STAFF SUBMITTAL

May 22, 2013  
Honolulu, Hawaii

Application for Stream Channel Alteration Permit (SCAP.3528.2)  
Streambank Stabilization, Moloa'a Stream  
Moloa'a, Kaua'i (TMK: (4) 4-9-014:021)

### EXHIBIT 7

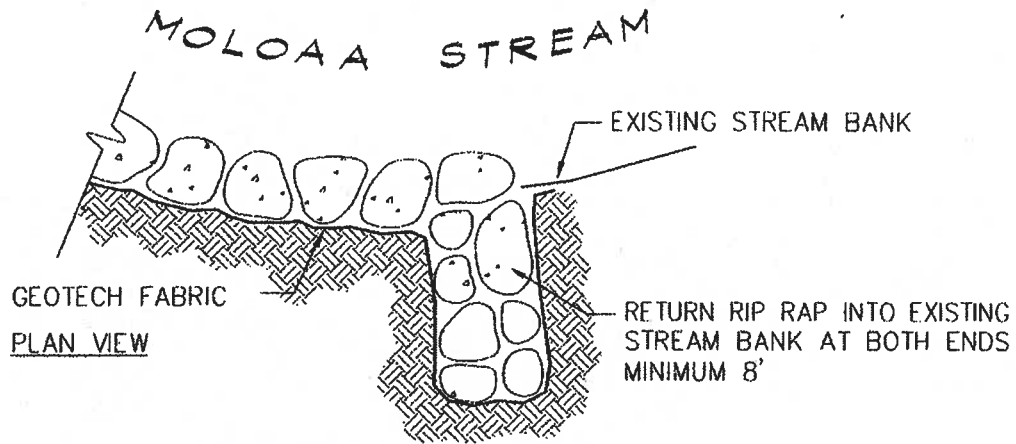
3. Section A-A included in the permit application is a schematic representation that does not faithfully portray the present geometry of the stream cross-section (Exhibit 7).

4. The applicant proposes to embed, to a depth of 1.5 times the riprap diameter, the lowest course of boulders in the stream bed, but does not explain how this will be accomplished in the presence of the bedrock shelf or exactly where in the stream bed the trench will be excavated (Exhibit 7).

5. The applicant proposes to grade successive courses to create a 45° (1:1) slope (Exhibit 7), but does not explain how it will be possible to do this without backfilling behind the proposed riprap installation and specifies that no fill other than riprap will be used.

**EXHIBIT 8**

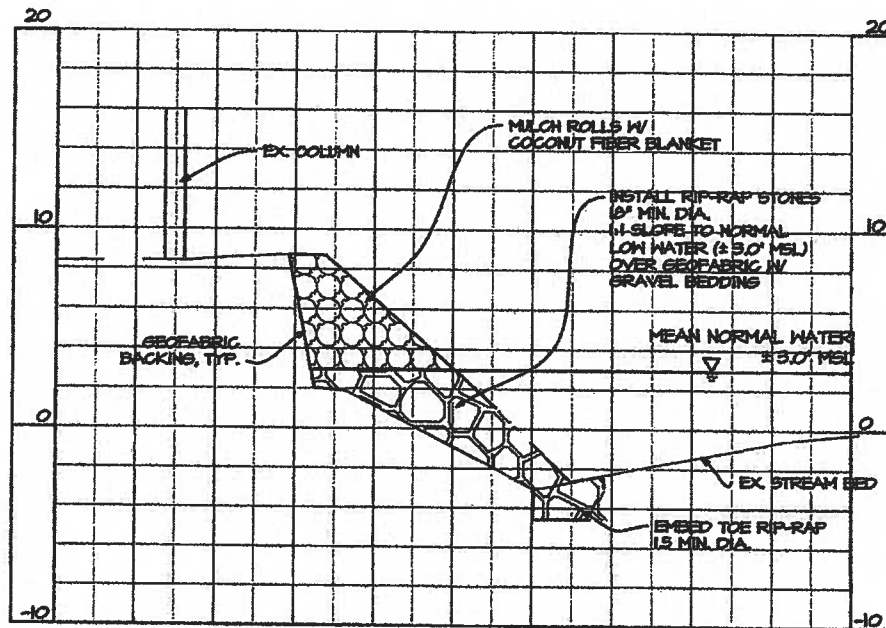
6. The applicant does not explain where the excavations necessary to return the riprap into the stream bank will be located or the amounts of materials involved (Exhibit 8).

**EXHIBIT 9**

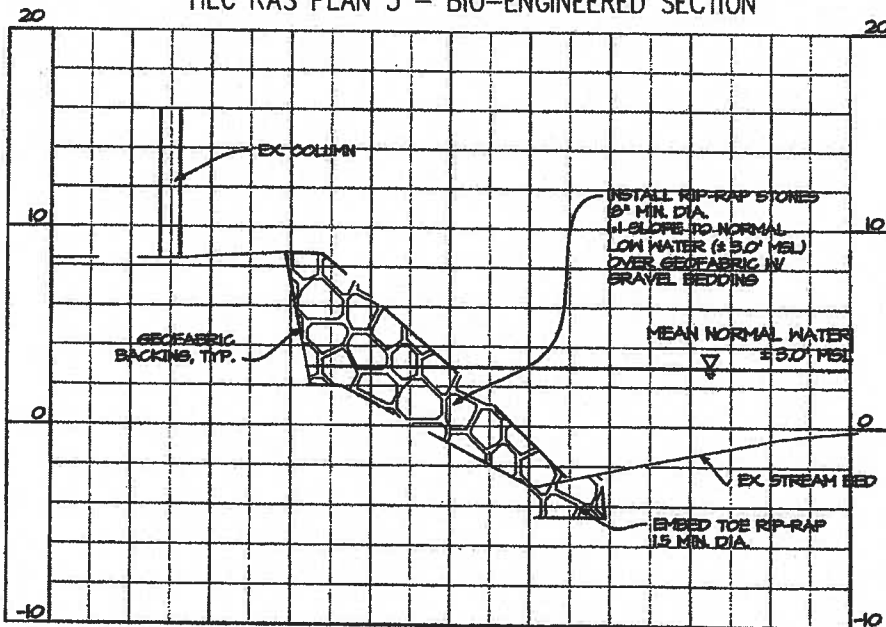
1. The size of the riprap is variously described as 18-inch diameter and 18-inch minimum.
2. Boulders that are proposed to be used to armor the bank on the applicant's property have already been delivered to the site (Exhibit 9). The quantity in evidence greatly exceeds the 200 cubic yards specified in the application for a Stream Channel Alteration Permit, approximately half of the boulders in evidence greatly exceed 18 inches in diameter.
